Access Compliance Report Public Rights-of-Way (Curb Ramps)

Intersection ID: 10039814 Main Street: TOM SHORT RD **Cross Street: N/A** Location: NW ADA ID: 5771D8C80EA0 Ramp Type: PerpDiag Initial Pass/Fail: Fail **Overall Compliance: No Severity Score:** 12.5

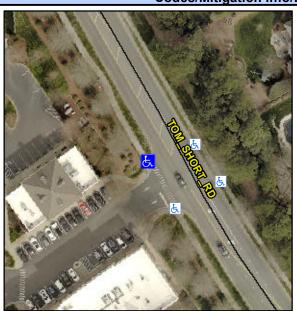
Possible Solutions: Remove & Replace Curb Ramp With Two New Directional Ramps or Equivalent. Restripe Crosswalk. Surveyor Notes: N/A PROW/ADA: Not Found, R304.2.2
